**ADDENDUM NO. 2  
TO THE  
BIDDING REQUIREMENTS AND CONTRACT DOCUMENTS  
FOR THE  
DIV IV DRY WEATHER PUMP STATION AND FORCE MAIN REHABILITAITON**

**OWNER:** **City of Anderson**

**ISSUED BY/ENGINEER:** Egis Group  
8320 Craig Street  
Indianapolis, Indiana 46250

**ISSUE DATE:** December 24, 2025

PLAN DATE: 12/01/2025  
DESIGN: JWS/JAK CHECK: JWS/JAK DRAWN: TEAM  
PROJECT NO. 120046  
SHEET NO. 1106

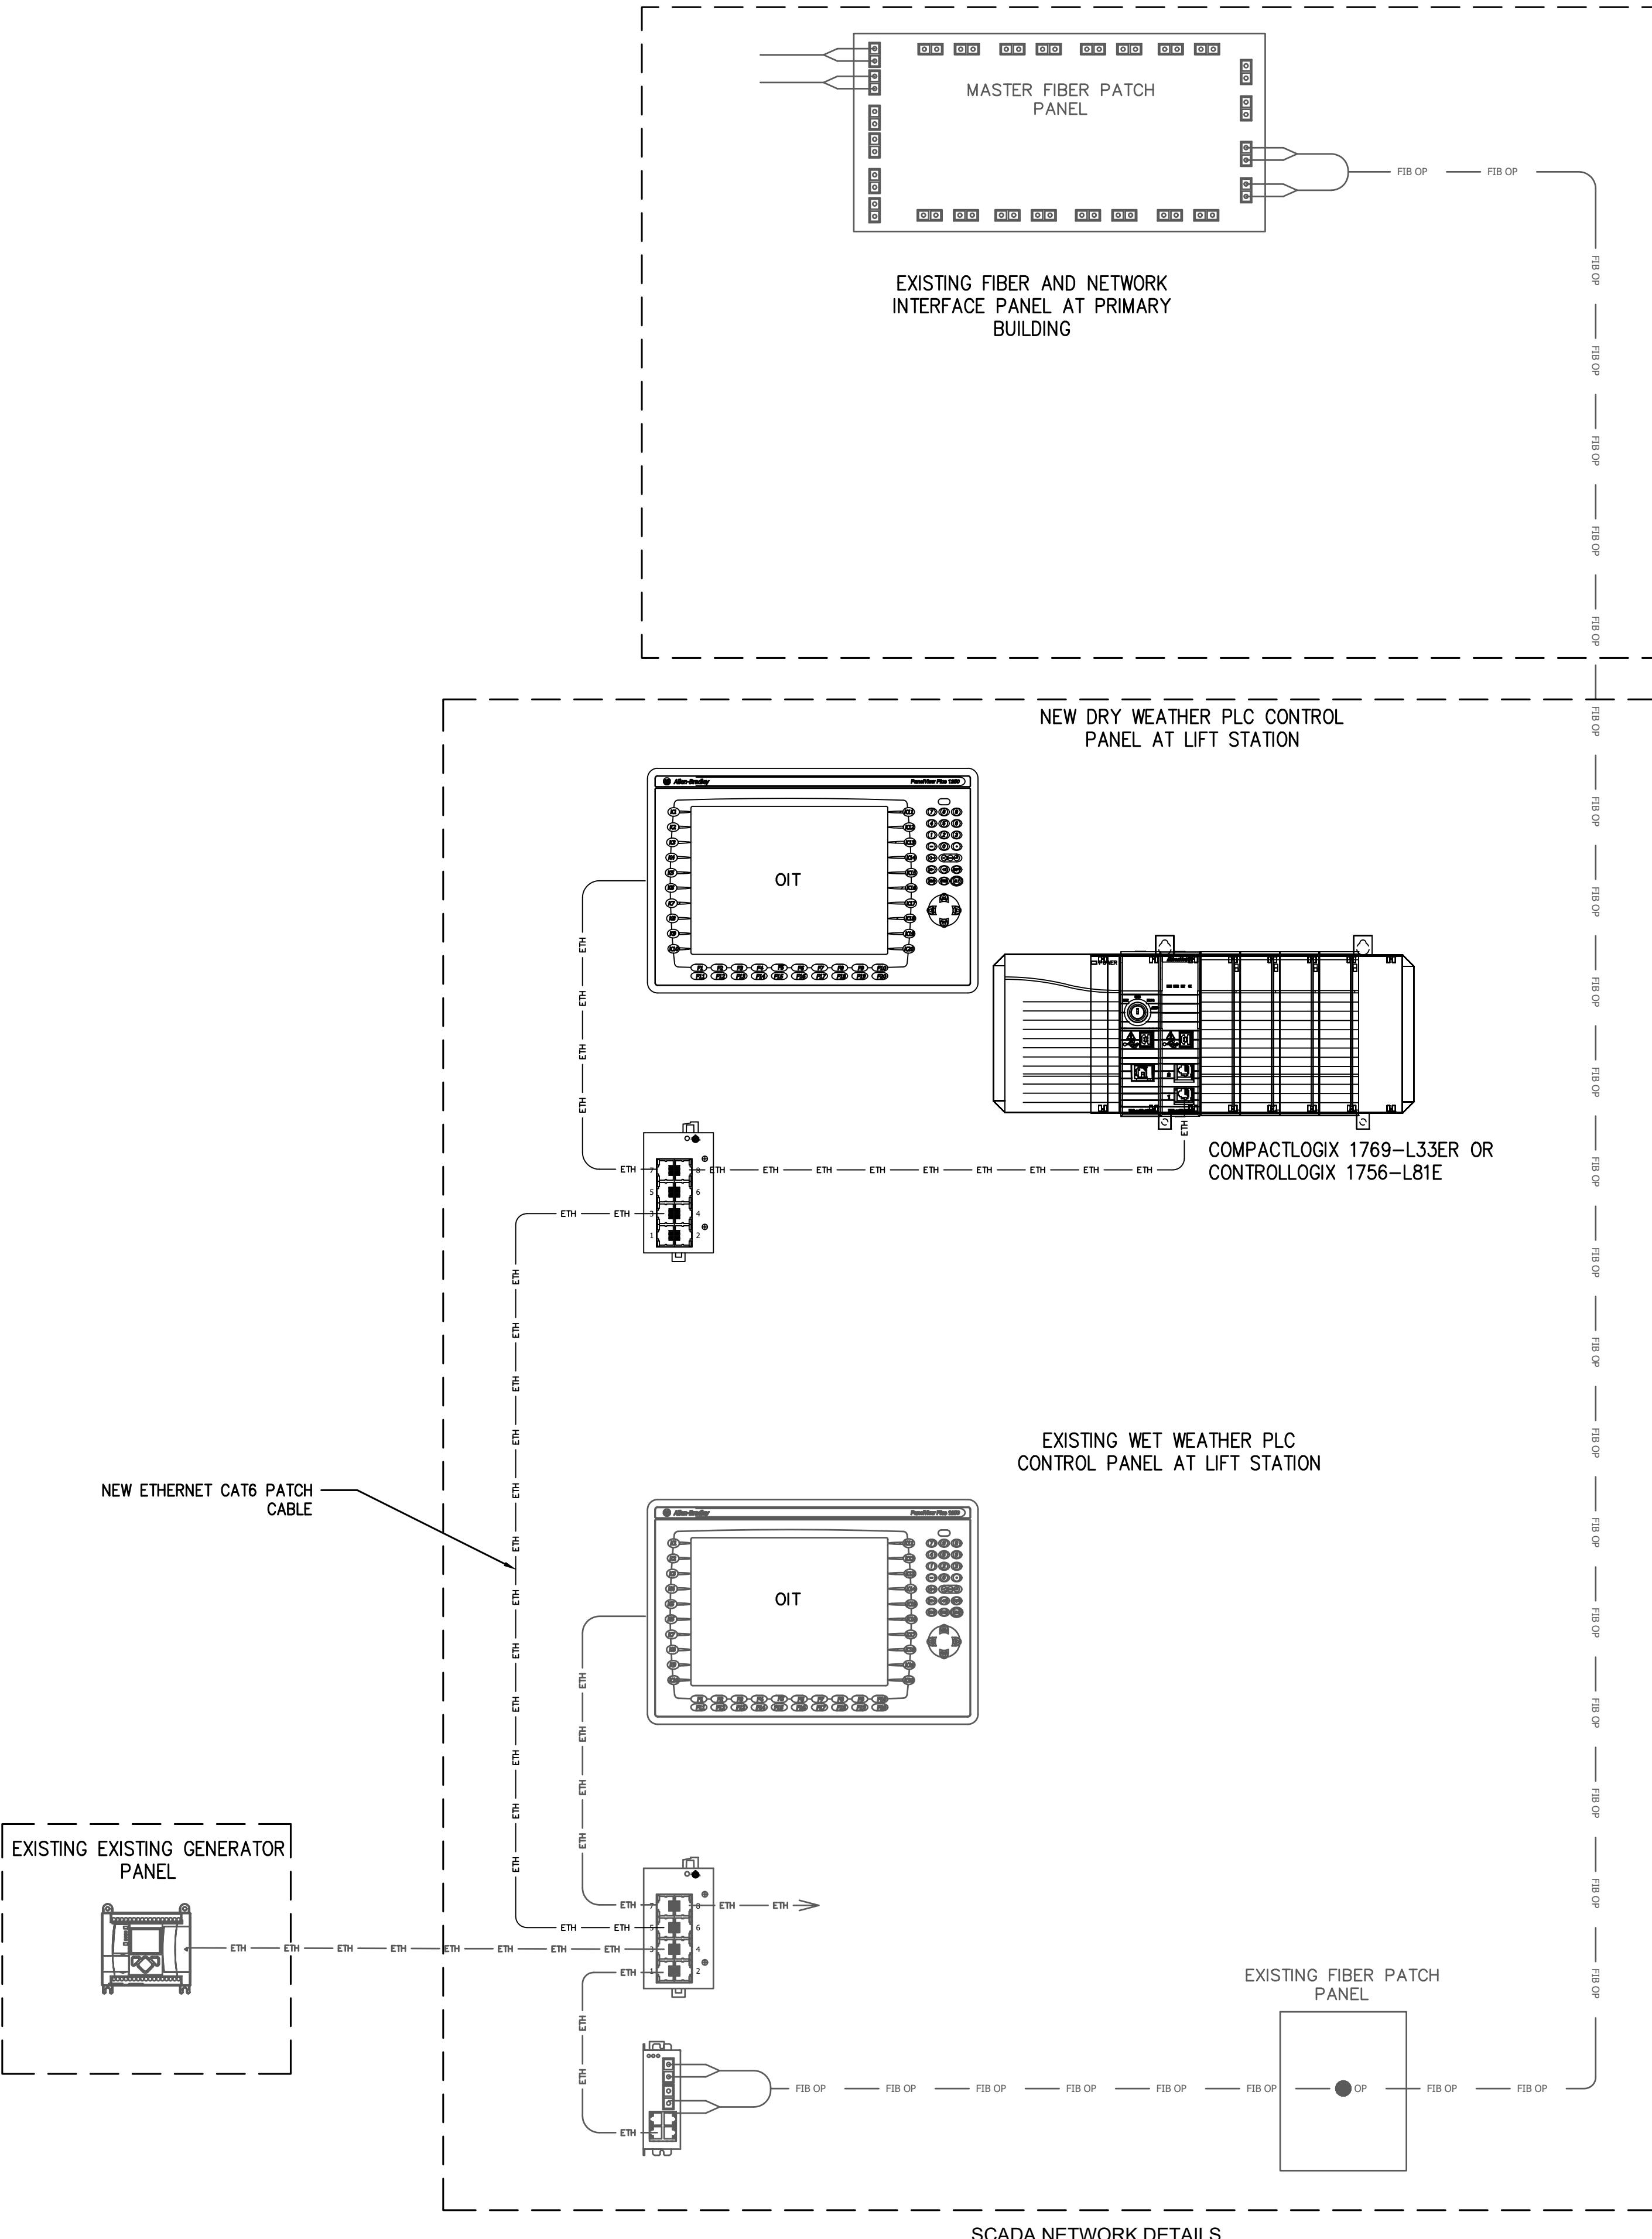
- A. Sheet C107 – Additional details have been added to Sheet C107.
- B. Sheet I106 – Additional information has been added to Sheet I106.
